RE: Point Ruston Development – Building 9/11A Building Permit Review (BLDCN 19-0087)

RE: Point Ruston Development – Building 9/11A Site Plan Review (SDEV 19-0116)

RE: Point Ruston Development – FEIS Addendum Request for Comments (LU 19-0116)

RE: Point Ruston Development – FEIS Addendum 2nd Request for Comments (LU 19-0116)

POINT RUSTON MASTER SITE PLAN

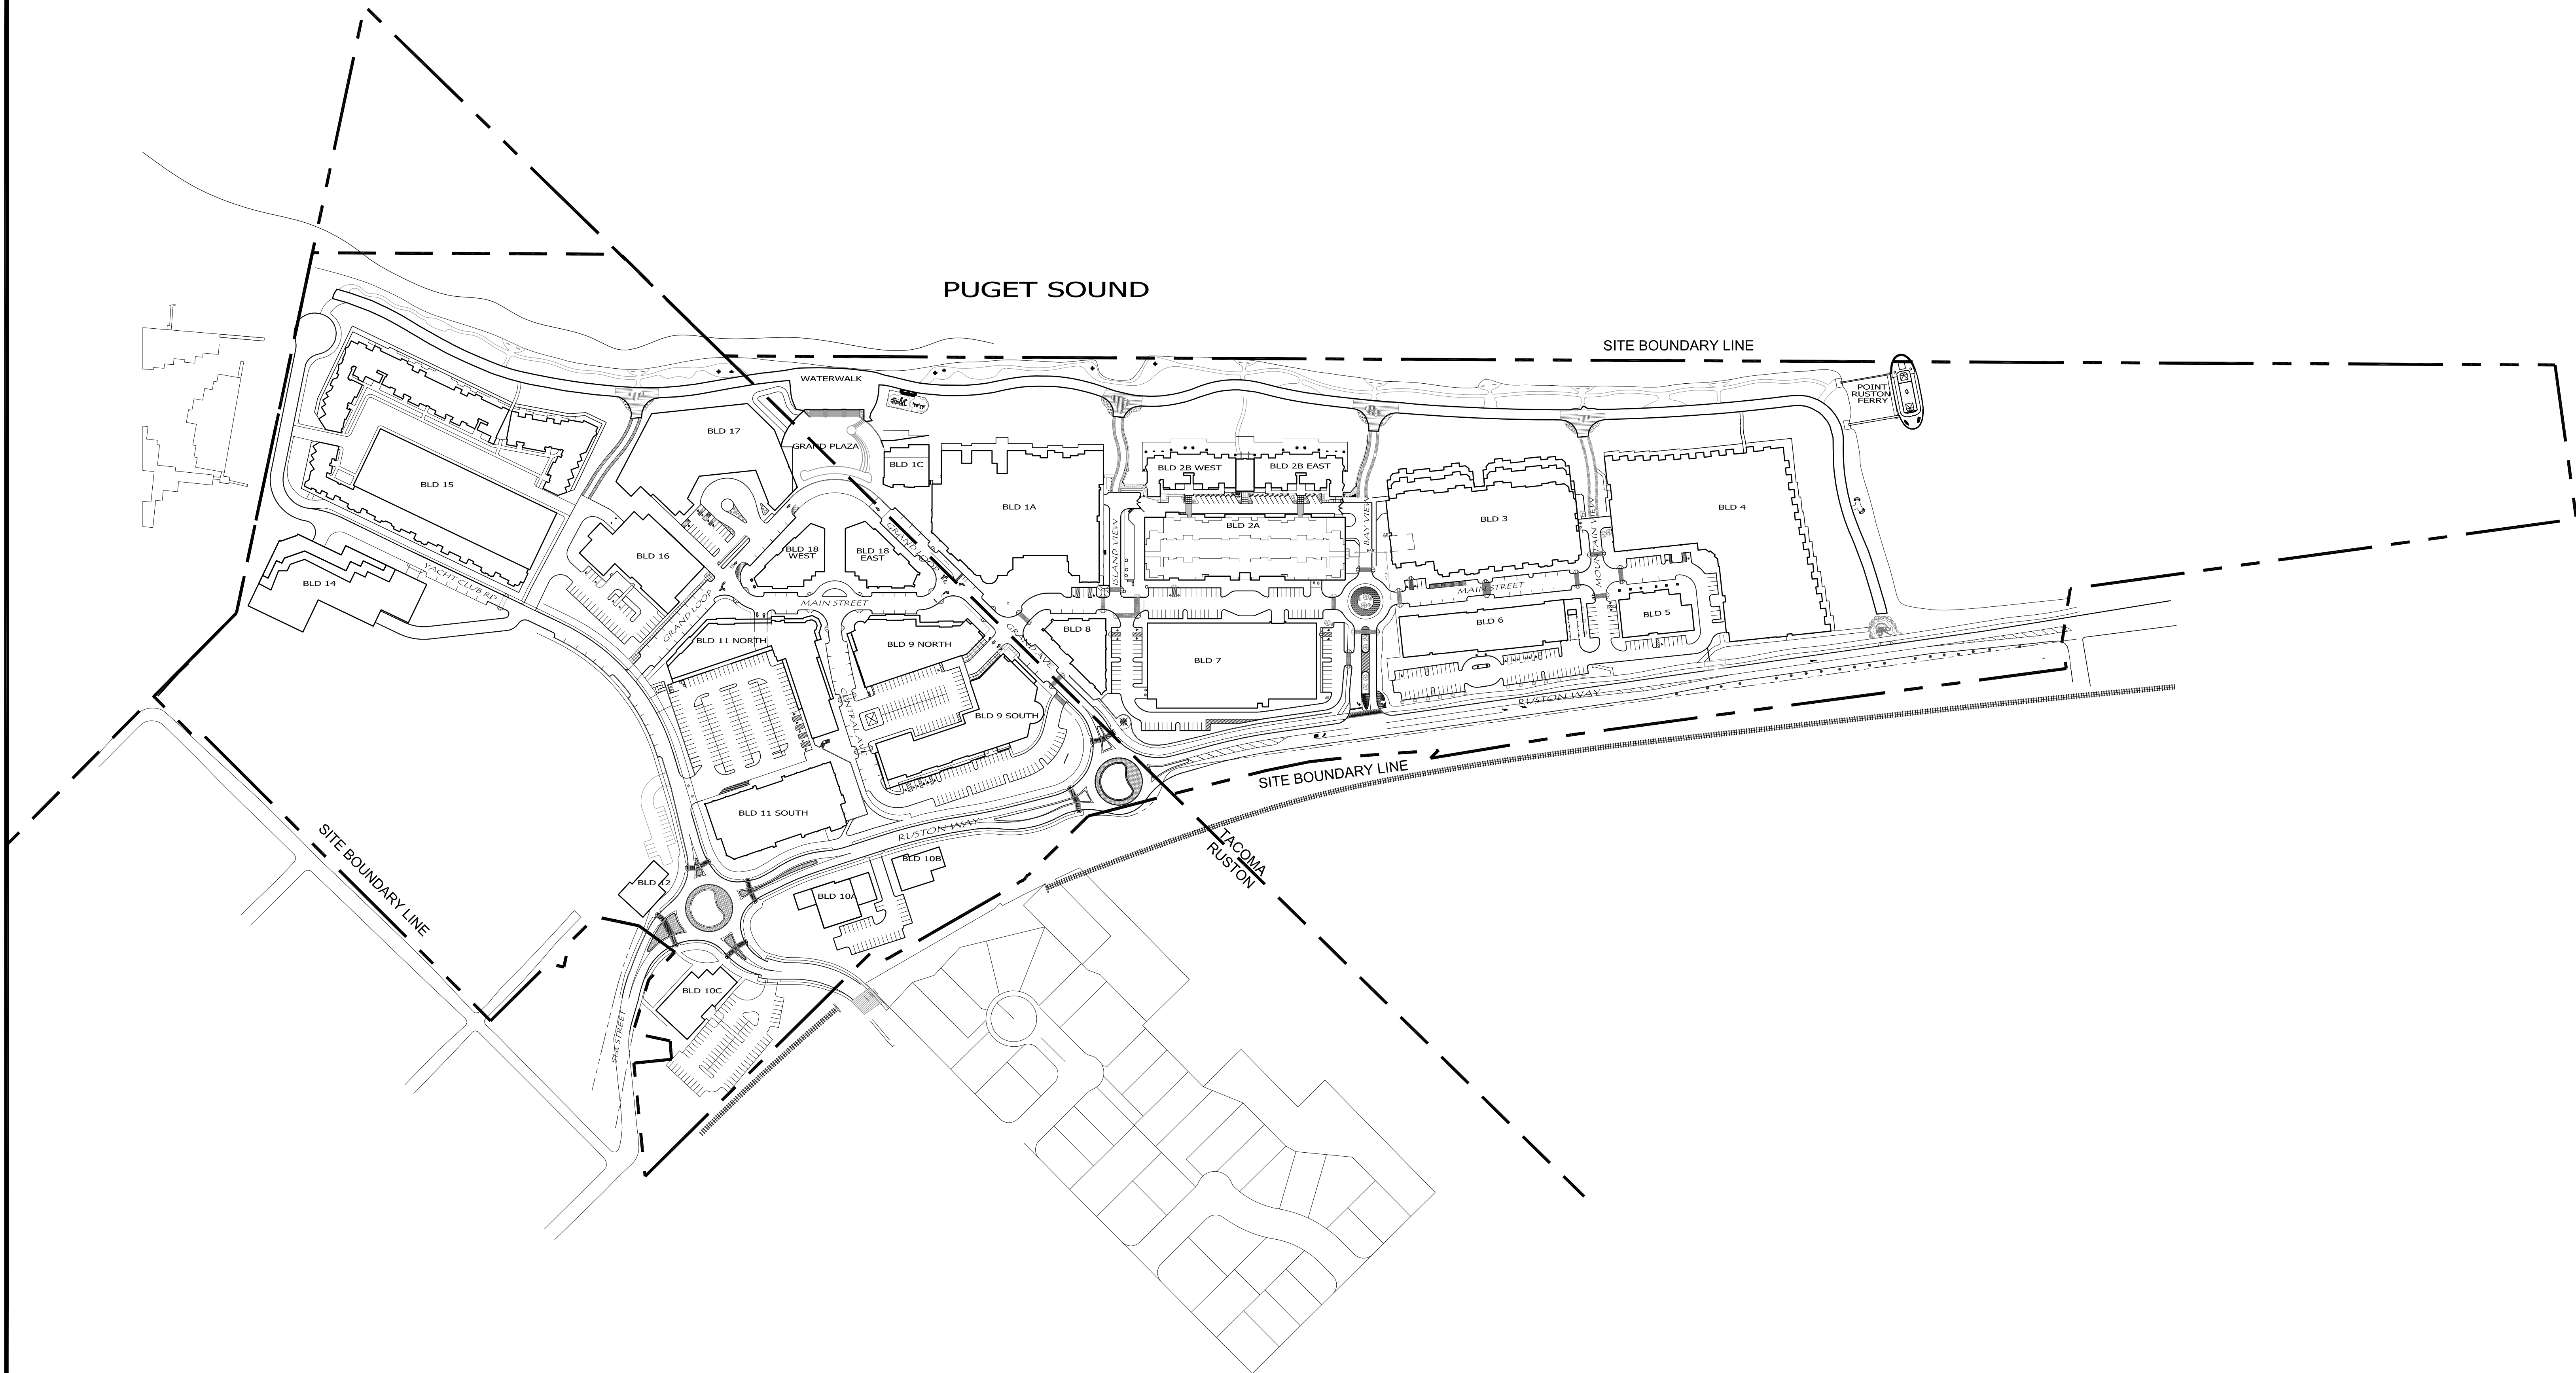
1) Elimination of Cooling Pond Open Space/Addition of Building 10C and Surface Parking.

The proposed plans indicate that the 75,000+ square foot open space and water feature, (commonly referred to as the “cooling pond”), is to be replaced with approximately 30,000 square feet of commercial space and an associated 76-stall surface parking lot, identified as Building 10C.

2) Elimination of Building 9 Open Space (Wellness Center Plaza)/Conversion to Surface Parking Lot.

The proposed plans indicate that the Wellness Center Plaza open space and continuous commercial frontage along Central Avenue and above Building 9 are to be replaced with a surface parking lot at roof level P3 of the parking garage. This proposed modification to the site plan eliminates required open space and significantly impacts the urban design quality of Central Avenue, which is classified as a pedestrian-oriented street by RMC 25.06.050(a) because it serves as the primary pedestrian link between the waterfront and thousands of surrounding Ruston and North Tacoma residents as they traverse the Point Ruston site through Market Plaza, Central Avenue, Central Plaza, Main Street and Grand Plaza to the water.

4) Elimination of Open Space/Conversion of Shoreline Public Access to Surface Parking.

The proposed Overall Point Ruston Site Plan submitted with this application indicates that the open space and shoreline public access space associated with the FSEIS, Point Ruston Master Development Plan, and Silver Cloud Shoreline Substantial Development Permits are to be eliminated and/or partially converted to a surface parking lot and access driveway located north of, and serving Building 16. Please refer to FSEIS Figure 11 (Site Plan – Connectivity), the PRMDP Site Plan (RMC 25.01.061), and the Silver Cloud Hotel Shoreline Substantial Development Permit for site illustration details; and RMC 25.01.061(m), (Table 9-1), which explains that the open space and shoreline public access shall be a “park-like” open space located between Buildings 15 and 16/17 consisting of a

5) Reduction in Urban Design Quality - Parking Lot Between Building 16 and Yacht Club Rd.

The proposed Overall Point Ruston Site Plan submitted with this application and related SEPA documents indicate that the Building 16 building façade required along Yacht Club Road has been eliminated and replaced with a surface parking lot between the building and the street. Placement of parking lots between the street and buildings would result in a significant reduction in urban design quality.

Because the application proposes to decrease the quality and quantity of required open space; reduces pedestrian connectivity; and results in a decrease in overall urban design quality, a **major** amendment to the Point Ruston Master Development Plan is required, prior to site plan approval. Major amendments are considered a quasi-judicial decision and are processed in accordance with RMC Title 19, which requires that a public hearing be held before the Ruston Hearing Examiner.

Attachment A - City of Ruston/Point Ruston FEIS Addendum Comments, November 22, 2019

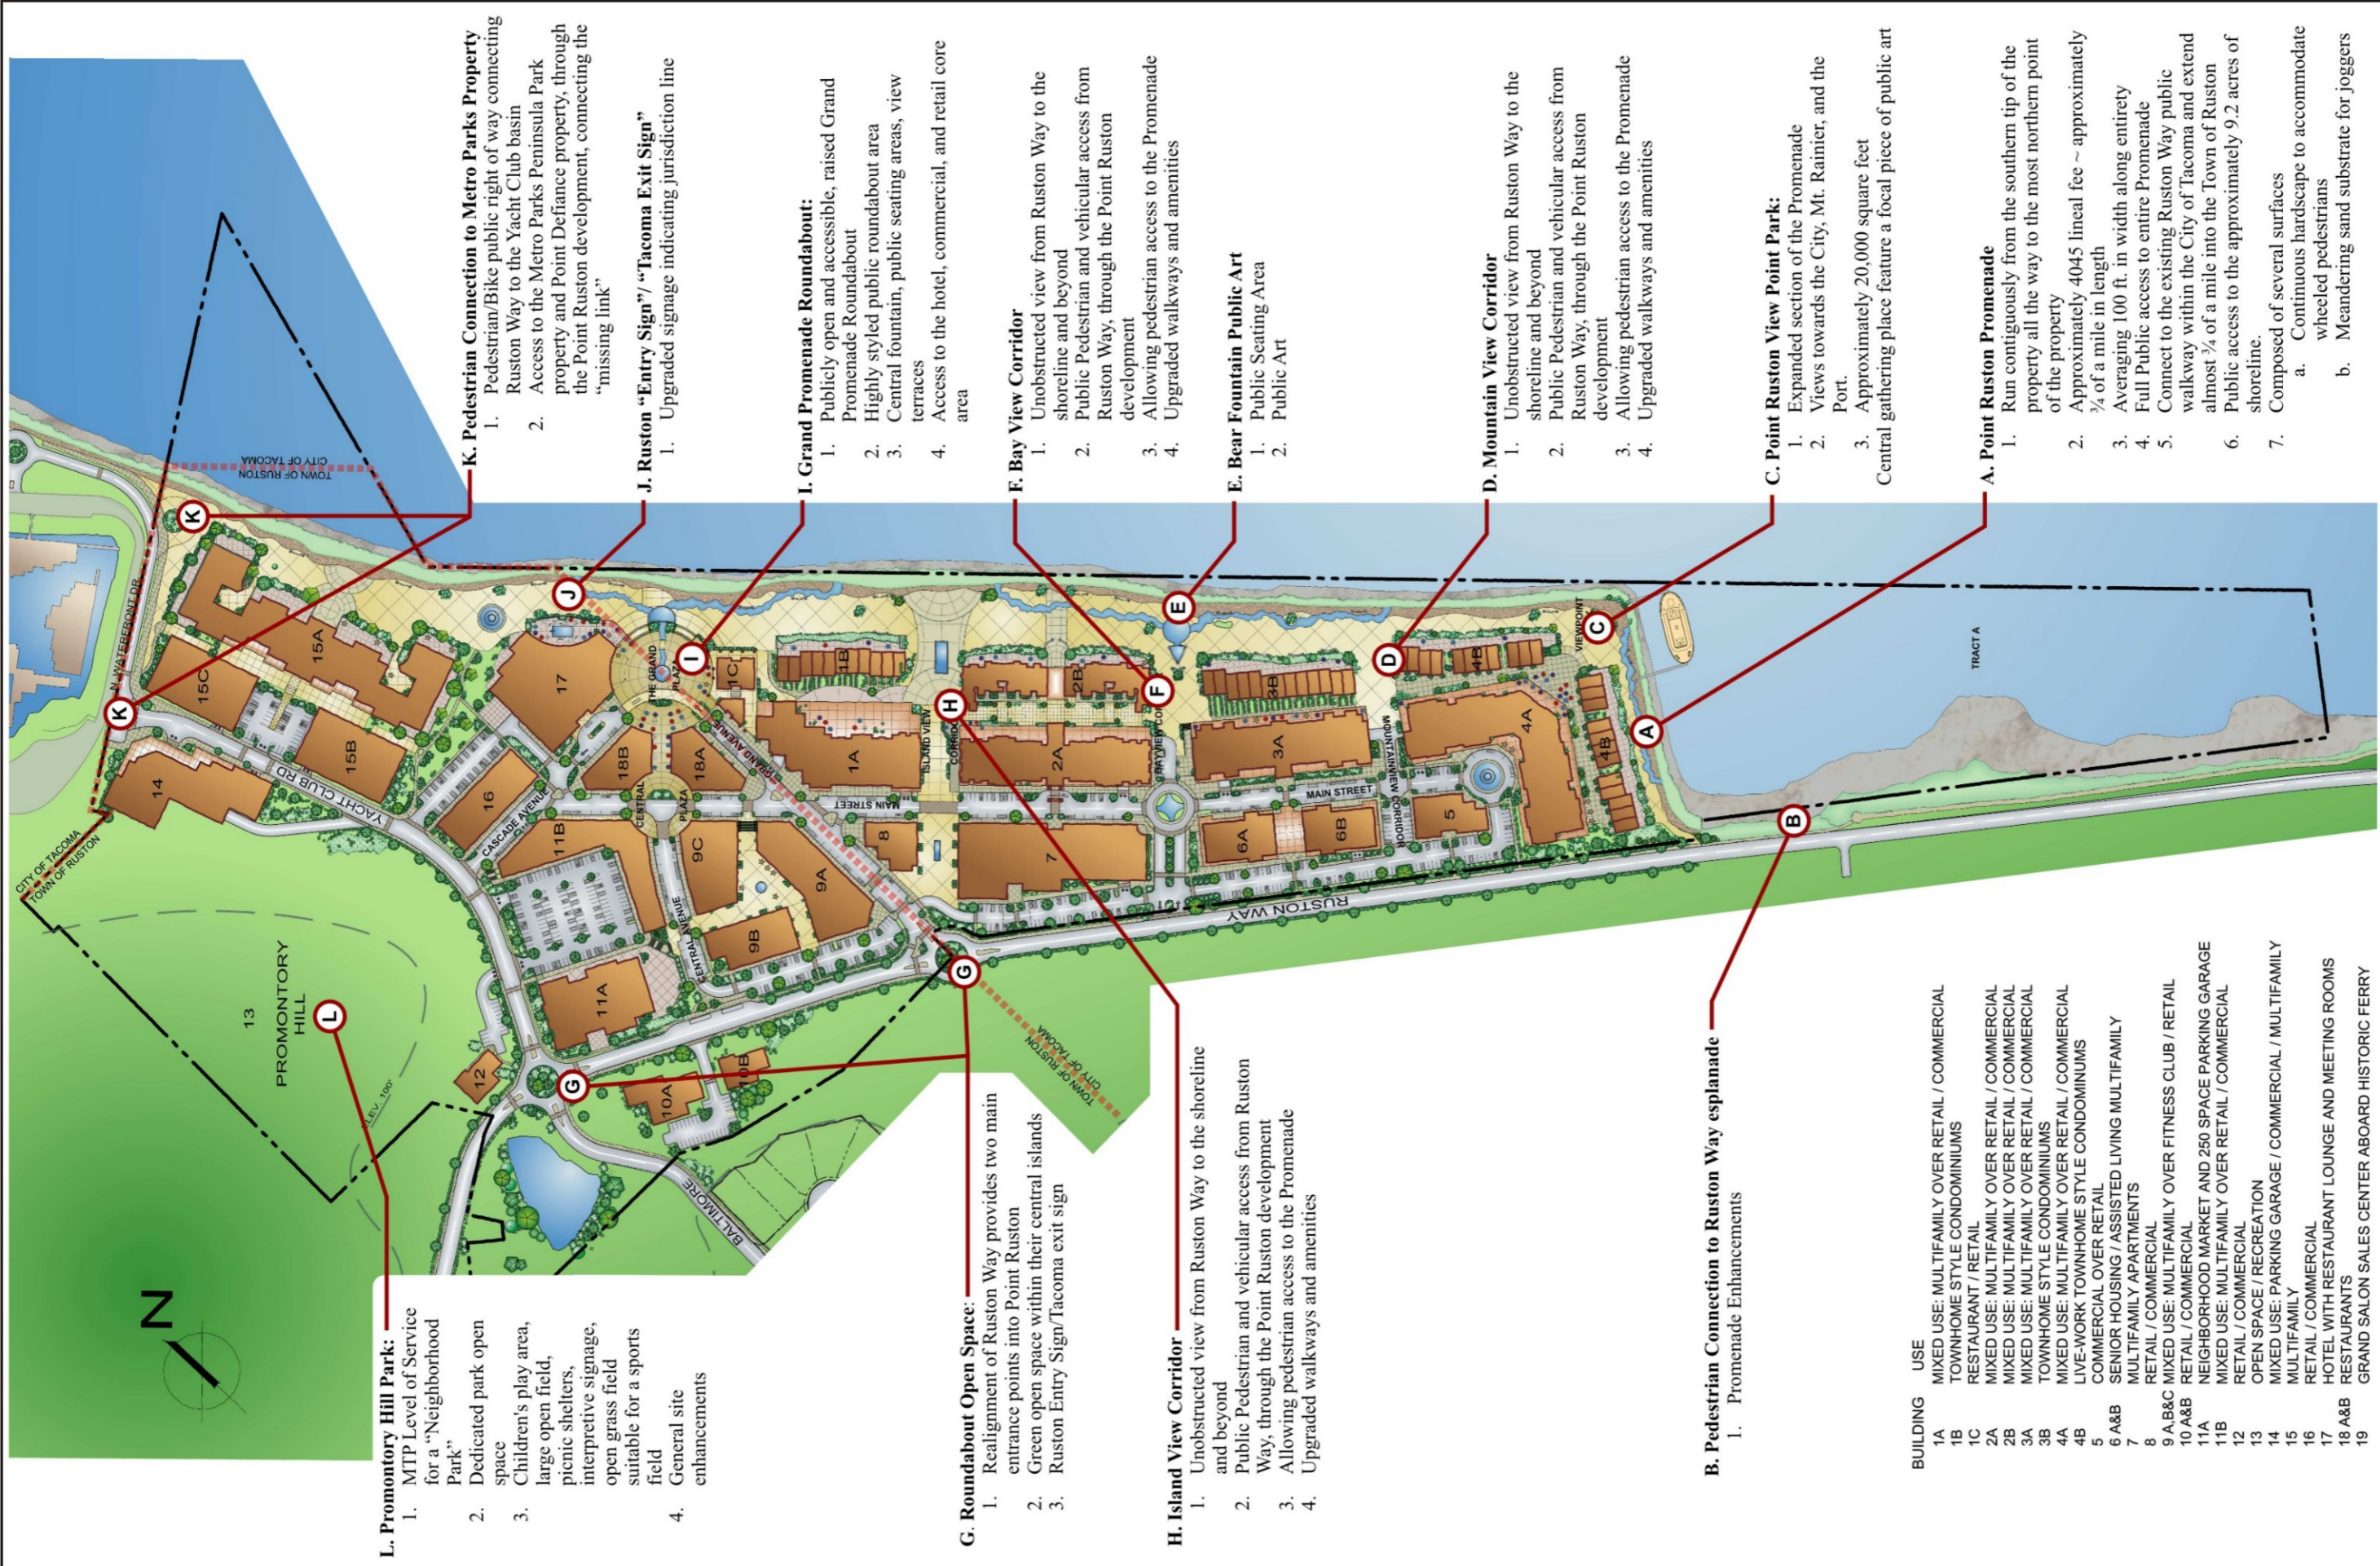
- a. **Waterwalk/Promenade Capacity.** The width of the hard-surface Waterwalk/Promenade path as constructed is not consistent with the width depicted on the FEIS site plan, PRMDP site plan, or Silver Cloud Hotel Shoreline Substantial Development Permit site plan. The revised multi-modal TIA requested above should also consider impacts to the capacity of this transportation route and provide for mitigating measures to increase its width and capacity. More specifically, improvements should be made to separate bicycle/scooter traffic from pedestrian traffic through a combination of lane striping, surface textures, curbing, signage and/or other alternate methods.

- b. **Promontory Hill Park Design and Construction Schedule.** The existing FEIS requires Promontory Hill Park to be designed to Metro Parks Tacoma (MPT) standards for a “Neighborhood Park”, which is dedicated to the public as permanent open space (via easement preferred), and includes a children’s play area, large open fields suitable as a sports field, picnic shelters, interpretive signage, and other general site enhancements. According to MPT standards, adequate parking would also be required, which would be most appropriately located along the Bennett Street frontage from N 53rd to N 54th as parallel on-street parking. The City of Ruston requests that the design and conveyance of an

- c. **Yacht Club Road Street Vacation.** Yacht Club Road functions as a shared private access driveway for Metro Parks Tacoma and Point Ruston and should not be maintained or owned by the public at tax-payer expense. For this reason, Yacht Club Road should be vacated.

- d. **52nd Street Pedestrian Connection and Alley.** A pedestrian and vehicle access facility connecting upper Ruston and north Tacoma residential neighborhoods to the Point Ruston site along the south side of Promontory Hill Park, behind Building 12 to a crossing at Yacht Club Road and the Ruston Market should be constructed by Point Ruston as mitigation. The alley/walkway should be available for pedestrians and also for utility/vehicle access to the rear of buildings fronting on 51st Street, including Building 12. This mitigation item must be completed prior to occupancy of Building 12.

- e. **Ruston Loop Trail Connection through Buildings 10A/B to Central Avenue.** This pedestrian connection from the future Ruston Loop Trail at Rust Park, through Buildings 10A and 10B, with a mid-block crossing at Ruston Way and Central Ave should be required as mitigation to partially address the impacts created by the expanded density and project scope. The addendum should clarify that this improvement needs to be completed prior to occupancy of either Building 10A or 10B.

- f. **Baltimore Street Improvements.** All existing improvements required under the current FEIS between the N 51st/Baltimore roundabout and N 46th Street shall remain as required mitigation. The City of Ruston understands that the City of Tacoma is in possession of a bond intended to cover the cost of construction of this mitigation item – which was intended to allow the developer to occupy Building 3 – Baker Building, since it caused the project to reach the traffic generation threshold triggering construction. It is Ruston’s position that this mitigation item must be constructed without delay. The existence of a bond in and of itself does not create the traffic mitigation facilities improvements that are necessary to serve this project.
